# **Final Environmental Statement**

related to the decommissioning of the  
Edgemont Uranium Mill

Docket No. 40-1341

Tennessee Valley Authority

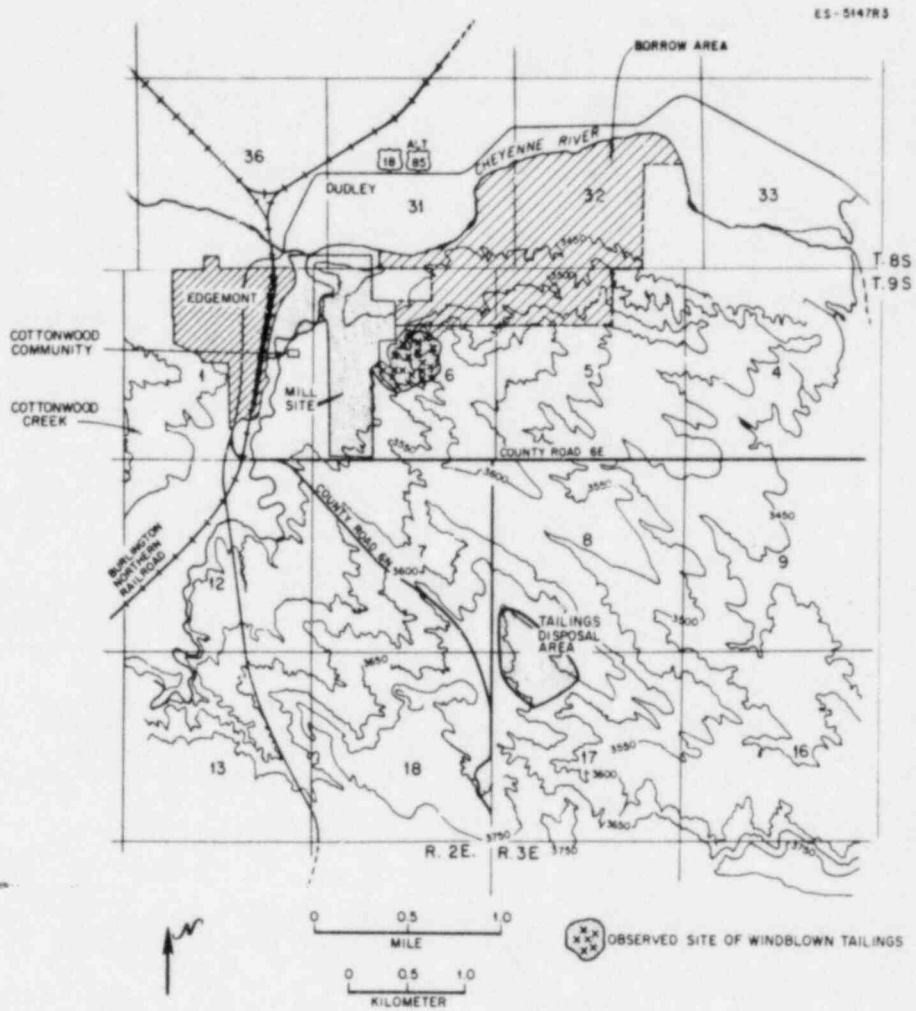
18. Page 2-4, Figure 2.1 - Should show location of Cottonwood Community.
19. Page 2-6, Figure 2.3 - The figure should indicate the location of the Cottonwood Community.

Also Figure 2.1 as referenced in paragraph 1, Section 2.2.2.3, does not indicate Cottonwood Community or Cottonwood Creek.

18. DES Fig. 2.1 has been revised.
19. The Cottonwood community is shown in Fig. 2.1.
20. Permeability values on p. 2-3 are reported values, not limits.
21. The sentence states, "During decontamination, radiation surveys will be conducted to identify any areas with unexpectedly high levels of contamination." This is an action to be taken by the licensee when decontaminating buildings and equipment to ensure that workers do not unknowingly encounter highly contaminated equipment which could pose a health problem.

Figure 2.1 has been revised to include Cottonwood Creek and Cottonwood community.

Fig. 2.7. Conceptual design of diversion channel along eastern perimeter of mill site. Source: Modified from ER, rev. 1, Fig. 3.5-1.

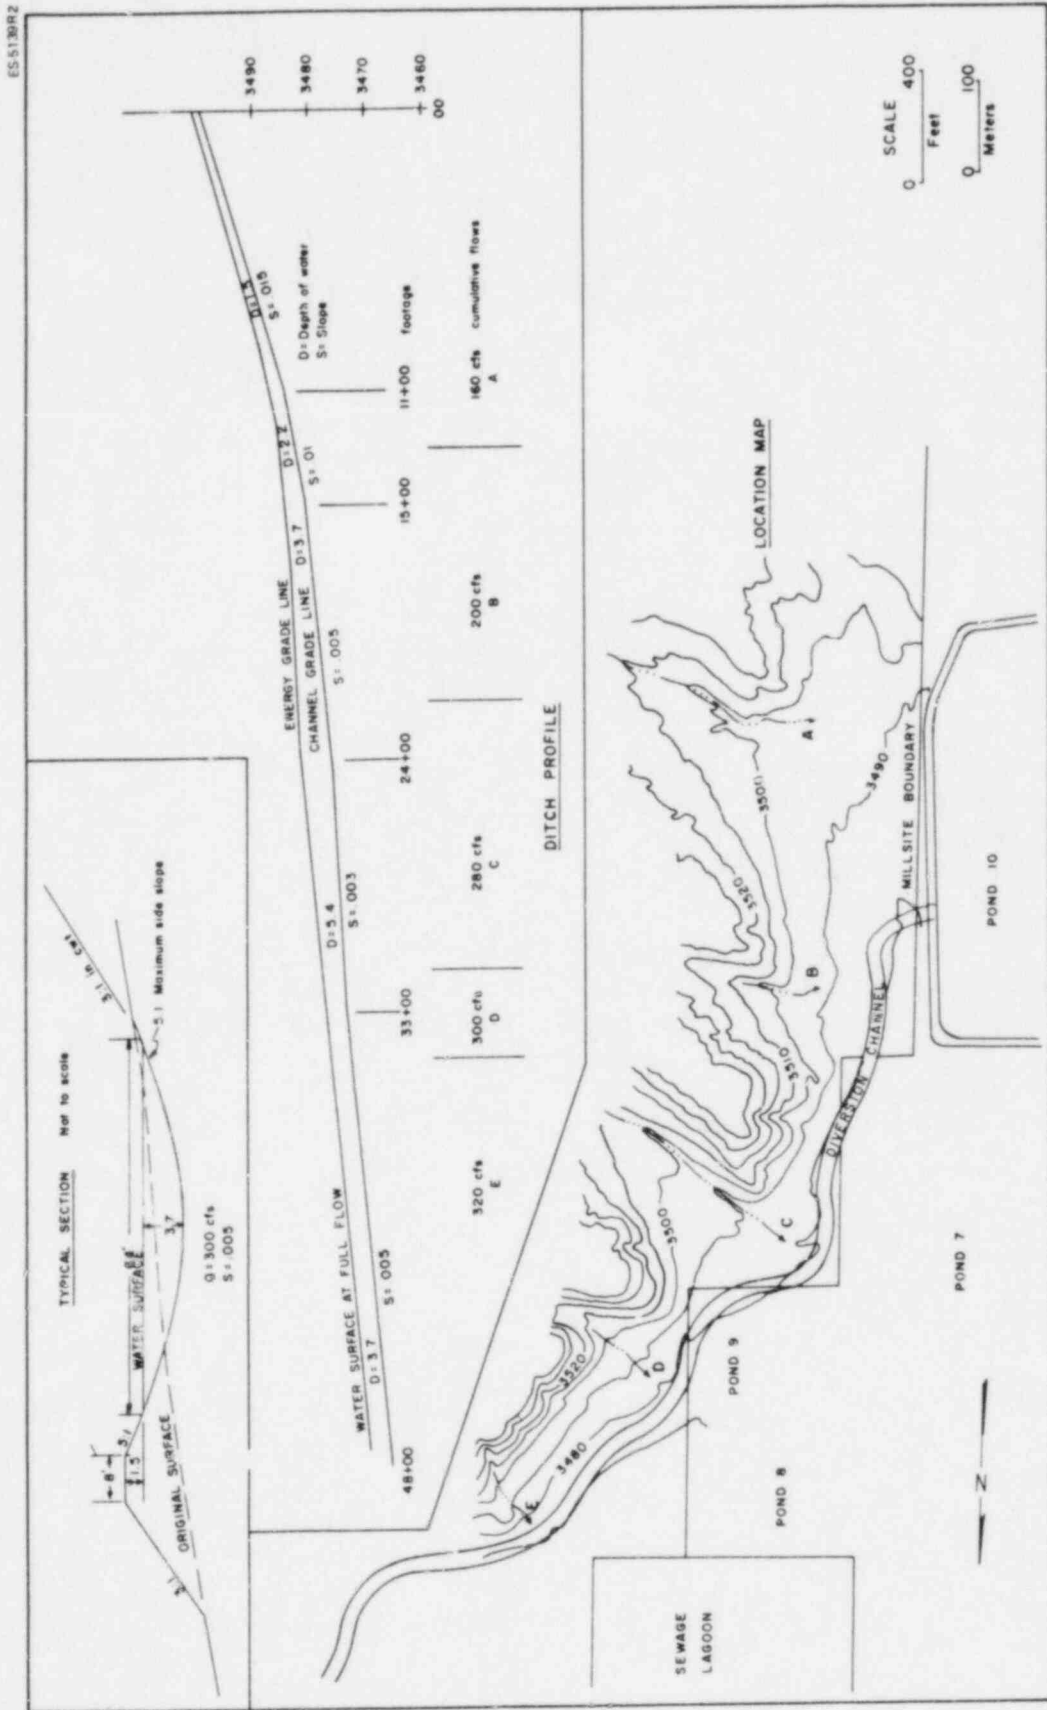
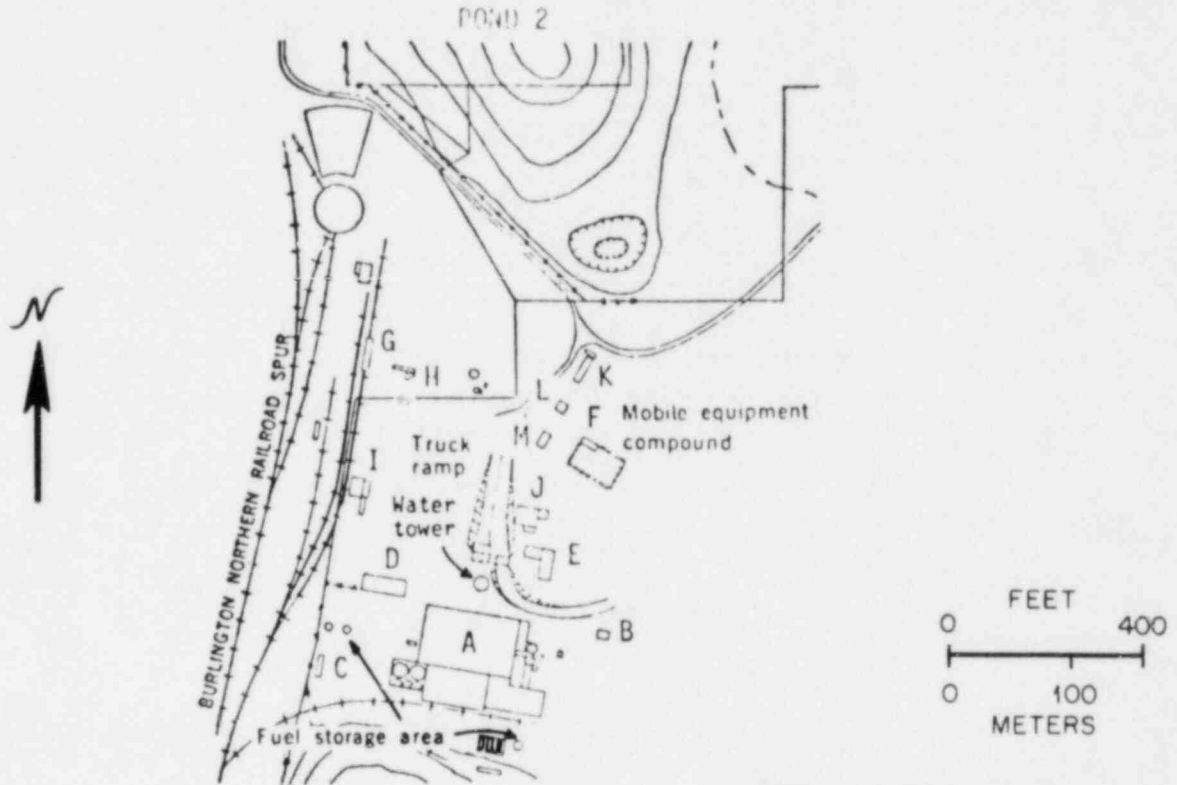
5. Page 2-10, Section 2.2.2.3, Paragraphs 1 and 2--Plans regarding the diversion ditch have been modified from those previously provided. Figure 2.7 is no longer applicable. The following rewrite describes the most recent plans.

Fig. 2.10. Edgemont decommissioning schedule. Source: ER, rev. 1, Fig. 3.6-2.

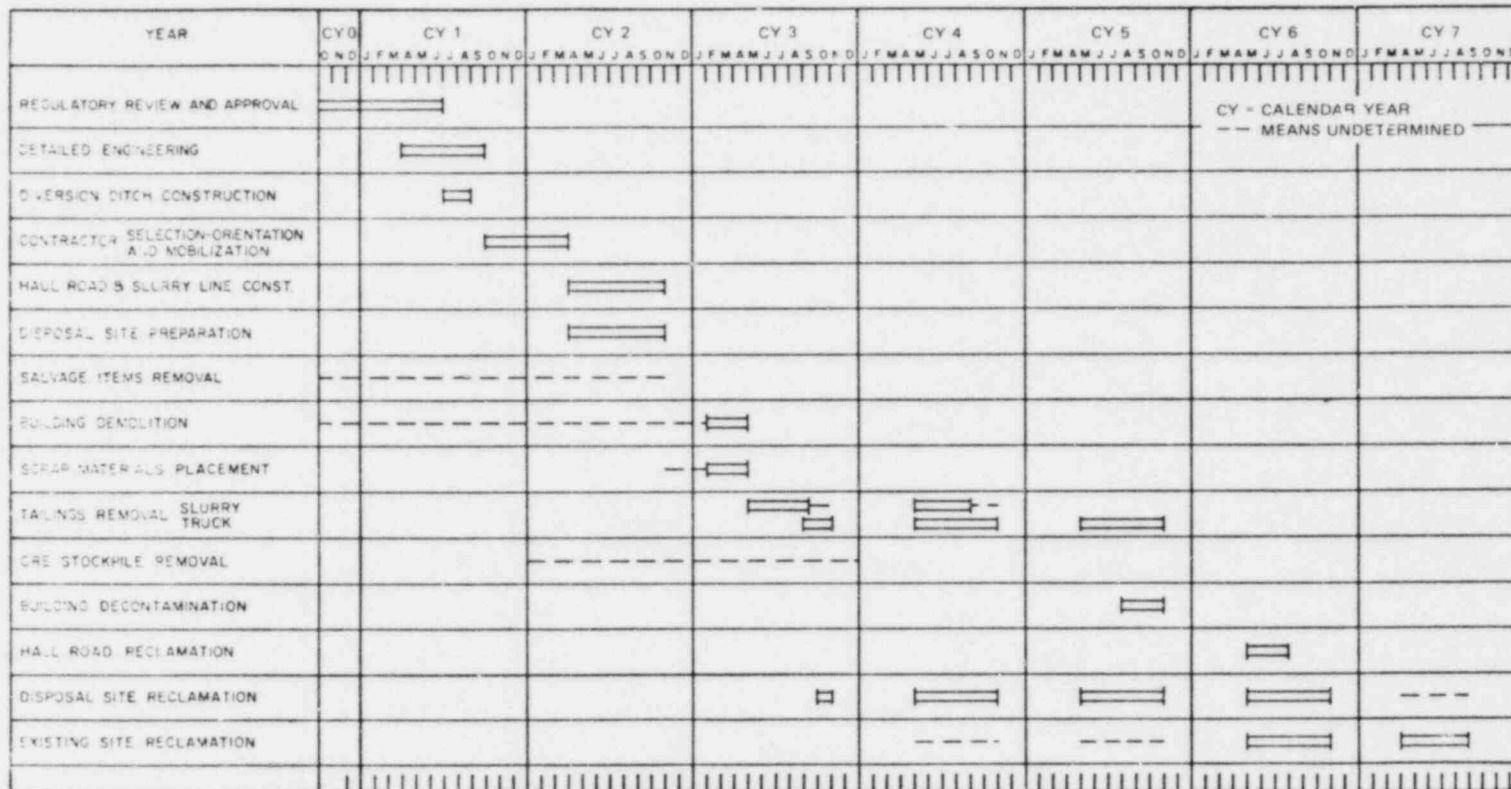
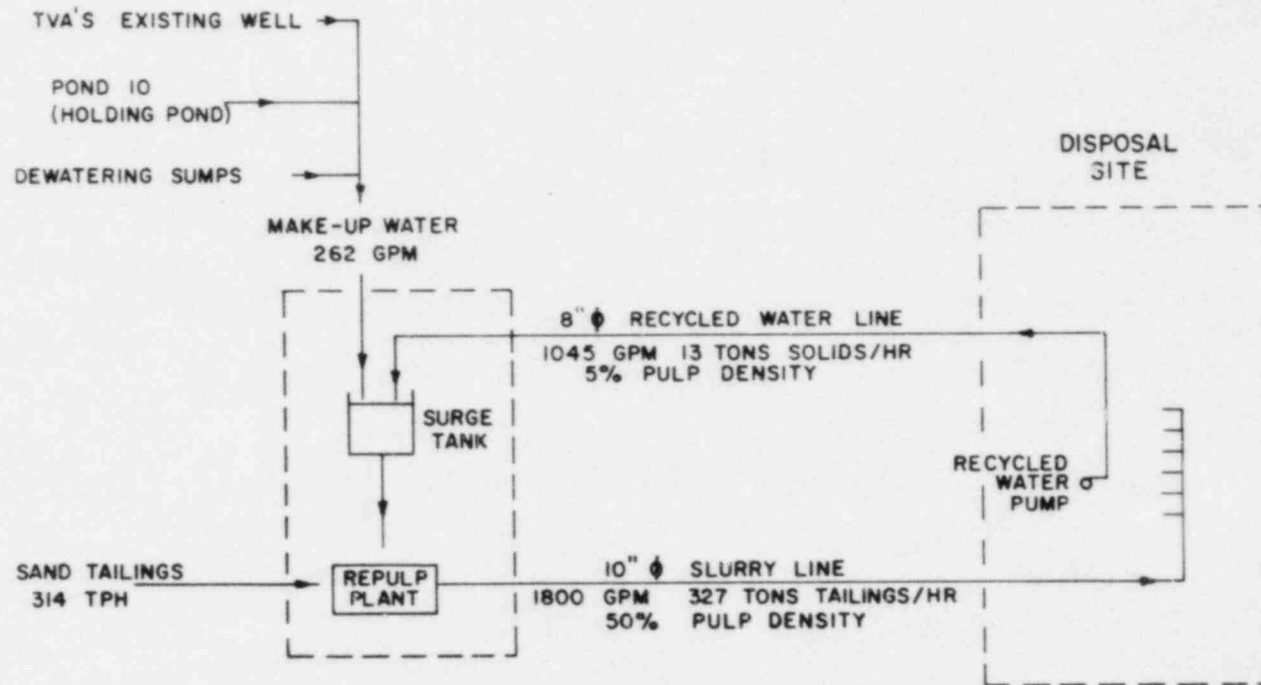
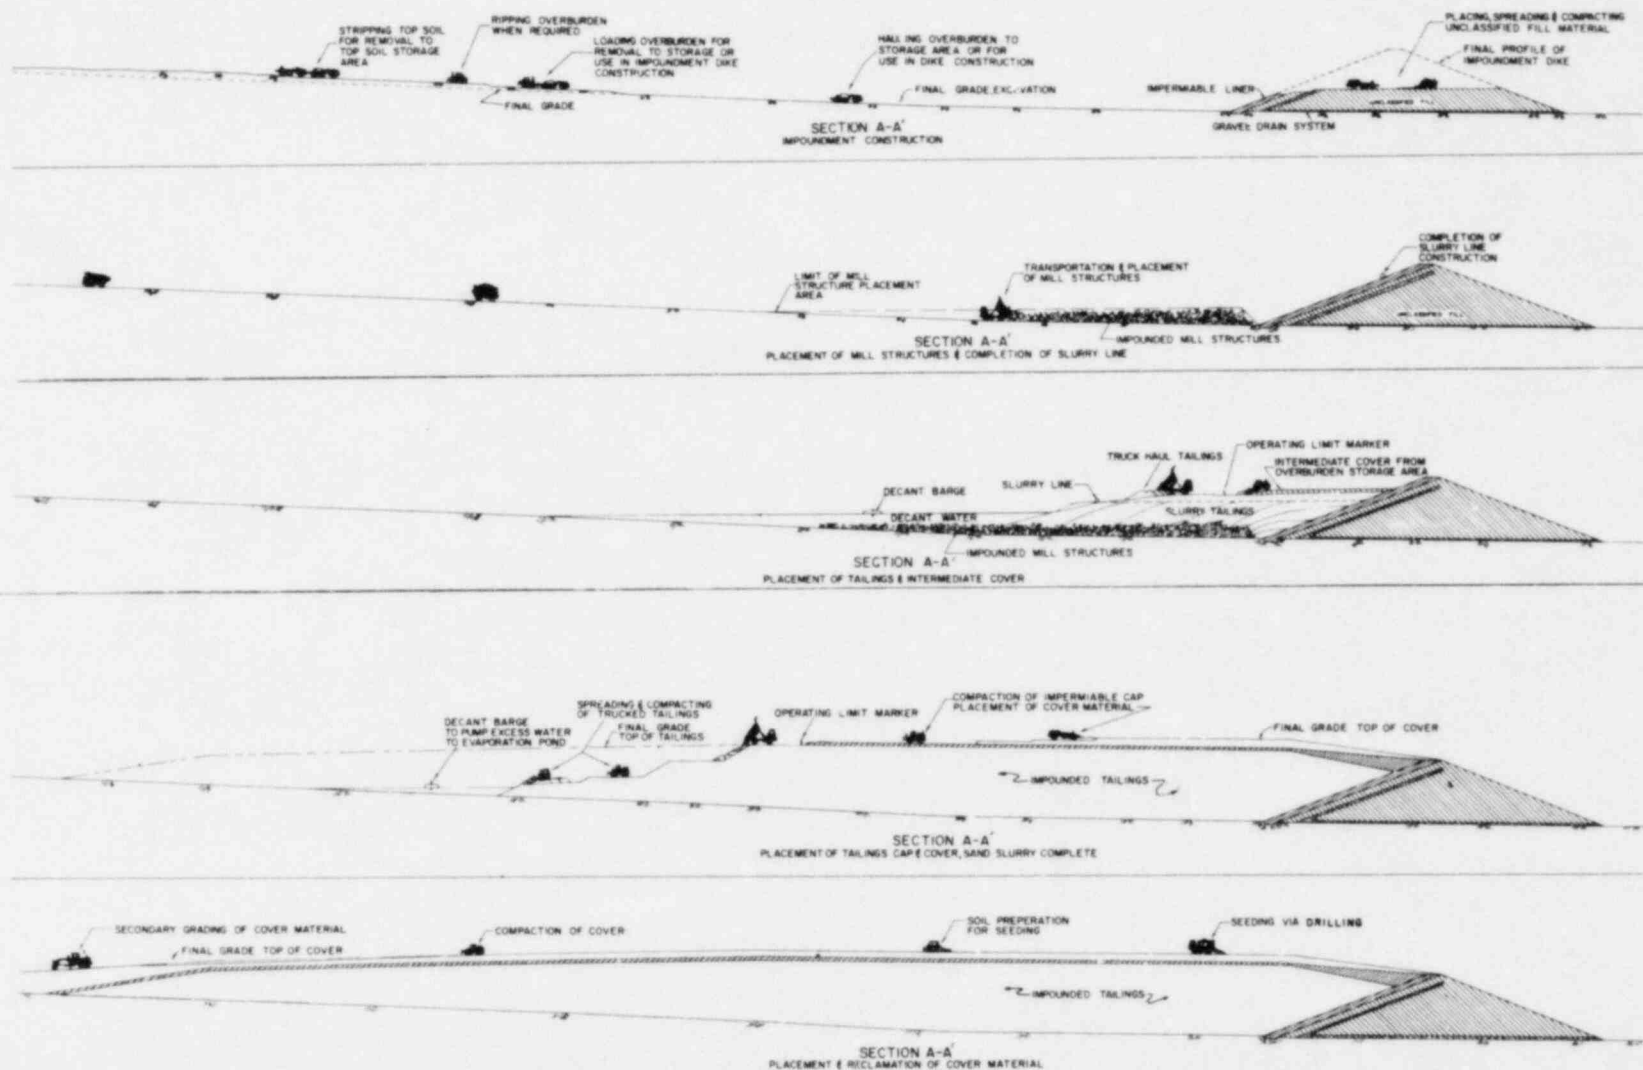
11. Page 2-17 Figure 2-10. It would appear that the haul road and slurry line construction cannot be conducted concurrently unless another access road to the disposal site is constructed. Also, it appears that land decontamination other than the tailings piles is not included in the schedule. Since it will require a significant effort and time to accomplish, it should be listed as a separate topic.

Fig. 4.1. Radioactive emissions from decommissioning and exposure pathways to man.

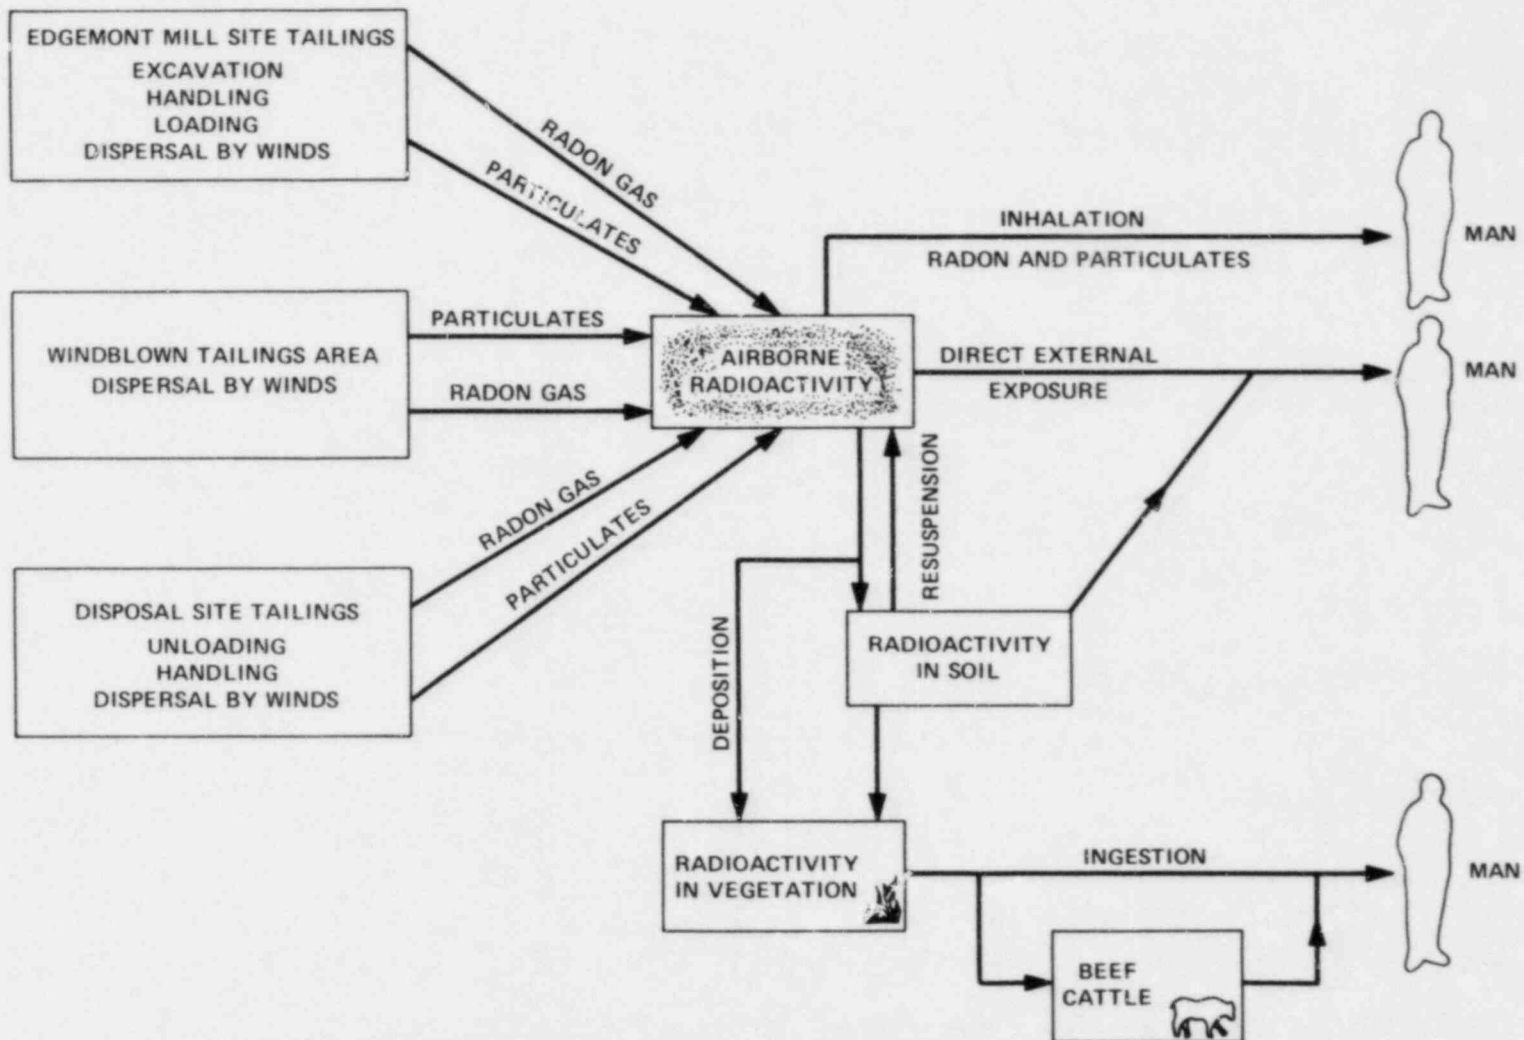
2. The environmental exposure pathways presented in Section 4.1.9, Radiological Assessment, and Figure 4.1, page 4-18, cover all the potential radioactive emission pathways that could result in exposure to individuals and local populations in the environs. The dose computational methodology and models in Appendix C used in the estimation of the radiation dose to individuals and dose commitments to populations within 1.6 km. (1 mile) of the mill site have provided reasonable estimates of the doses resulting from decommissioning operations. Table 4.10 presents the predicted annual dose commitments to individuals in the vicinity of the Edgemont site, and Table 4.11 compares the dose commitment with the NRC radiation protection standards and with background radiation estimates. Since the object of the decommissioning project is to reduce individual and population exposures, the dose reduction factors are equally as important as the fractions presented. It would be helpful, from a health effects standpoint, if Section 4.1.9.4 could be expanded to discuss the reductions and indicate the cost/benefit as related to the individual dose. The dose reduction factors based on the totals for all pathways for the four selected locations for whole body, bone, lung and bronchial epithelium are about 5, 22, 11 and 350, respectively. Table 4.13 presents the predicted annual environmental dose commitments to local populations within a 1.6 km. radius of the mill site. The dose reduction factors based on the totals for all pathways for the whole body, bone, lung and bronchial epithelium as a result of the decommissioning operation are 175, 190, 177 and 352, respectively. The dose reduction factors should also be discussed in Section 4.1.9.5 and the text expanded to indicate the cost/benefit as it relates to population dose.
